Watershed Management Commission

Project 100 Maple Grove, Project #2020-002

Technical Advisor

Phase I Grading

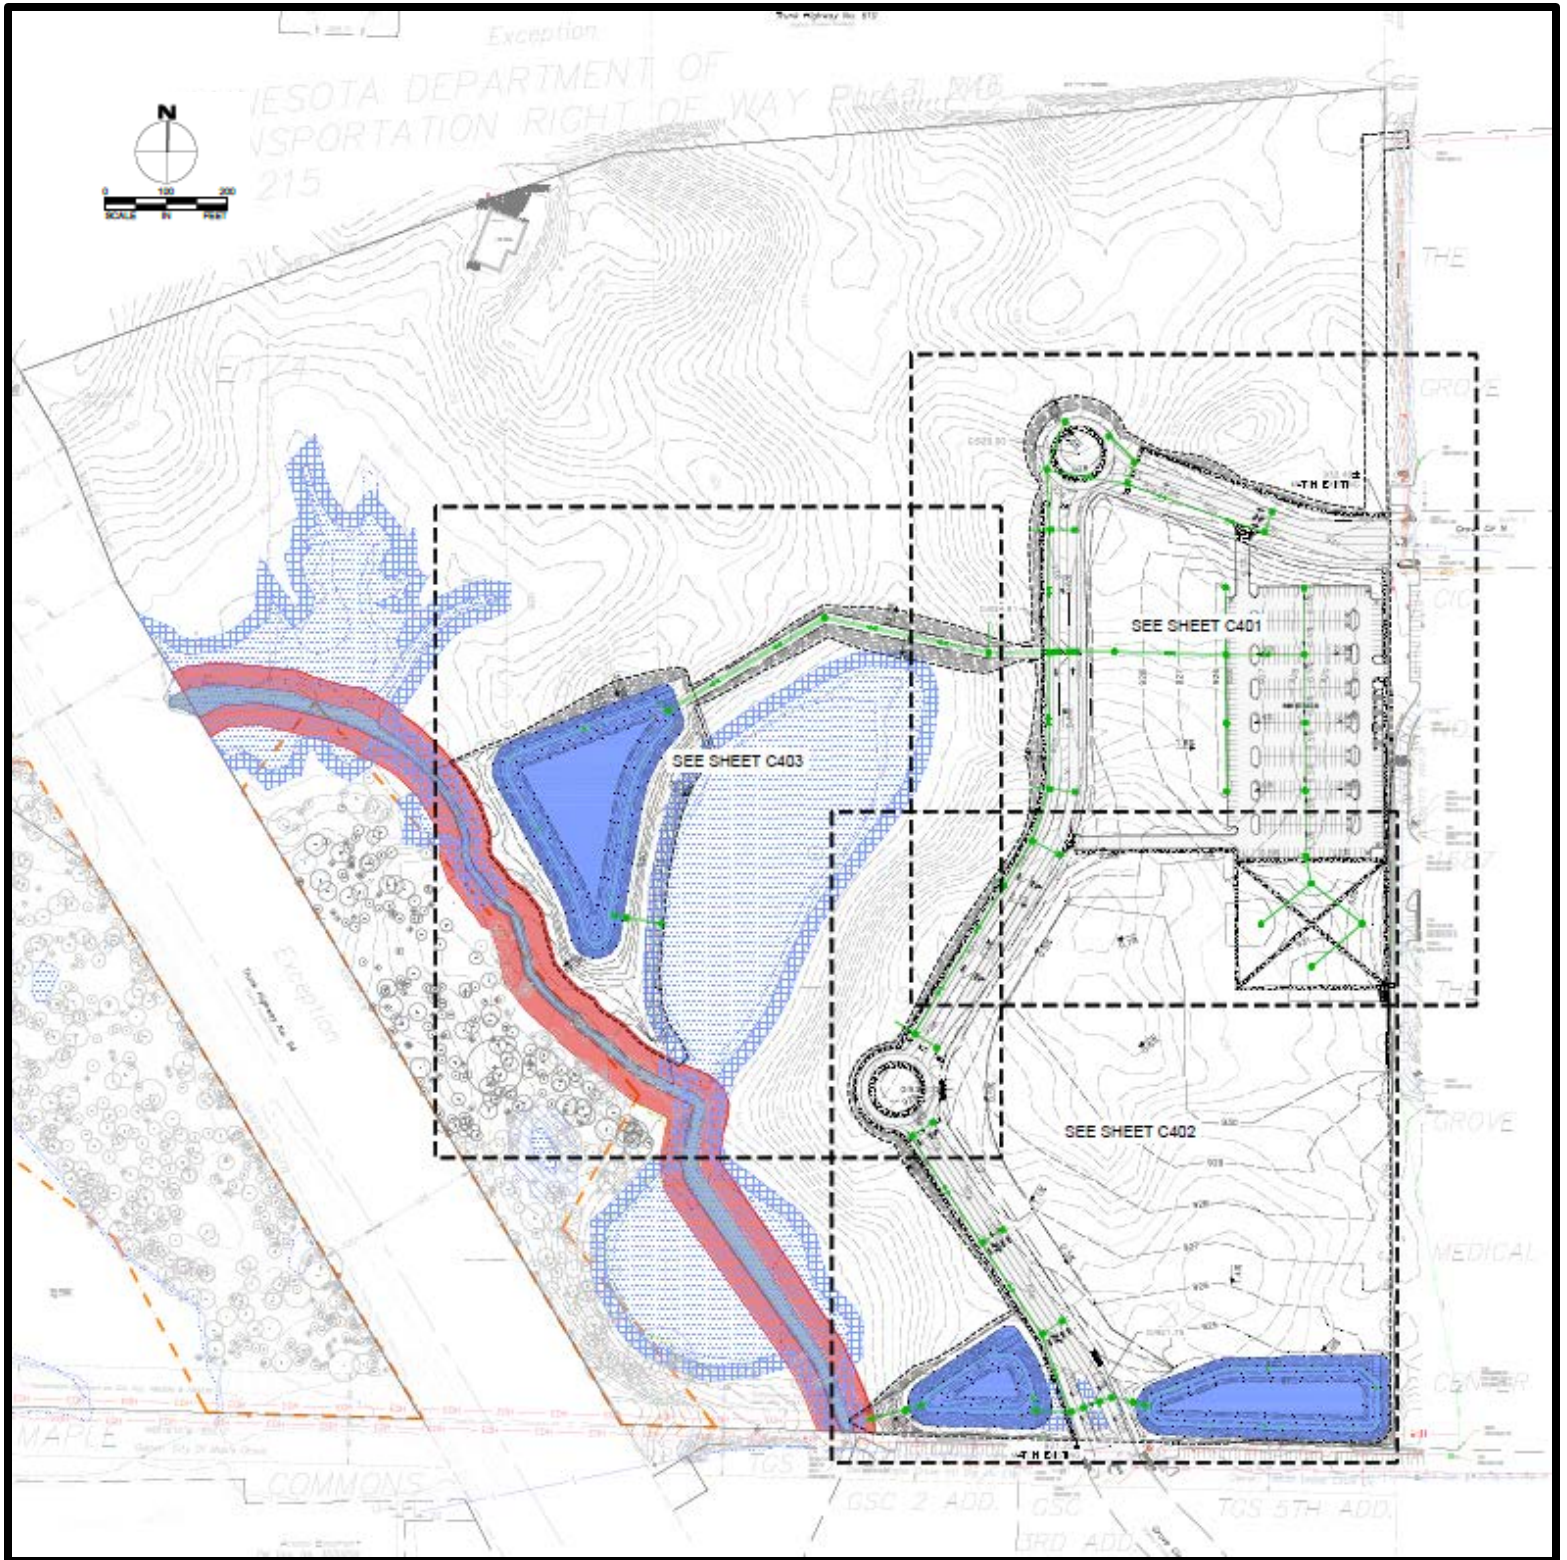
- 25) No SWPPP plan was submitted with the project. A SWPPP or similar plan is necessary for the Commission's review. At a minimum, the following items should be included on the SWPPP plan.
 - a. The storm sewer mounding to pond 1 will create a dam to about 3.5-4.0 acres that drain towards it from the north. A temporary drainage plan should be accounted for at that dam.
 - b. Erosion control blankets must be provided on slopes steeper than 4:1.
 - c. Double silt fence is required around existing wetlands in proximity to construction activities.
 - d. Locations of the ditch blocks or bio-rolls to prevent channel erosion must be provided.

- e. If the permanent ponding basins are to be utilized as temporary ponds during construction, this must be noted on the plans. Additionally, a separate sequencing plan must be developed on these temporary basins keeping in mind;
 - i. There are to build as a sediment control BMP
 - ii. Timing of their construction and restoration during and after construction work.
 - iii. Temporary diversion of water into them during construction
 - iv. Temporary outlets during construction.
- f. All areas outside of the construction limits must be seeded down to a pasture mix or similar long term permanent vegetative cover. If this is not done, additional silt fence around the wetlands and water course will be necessary.
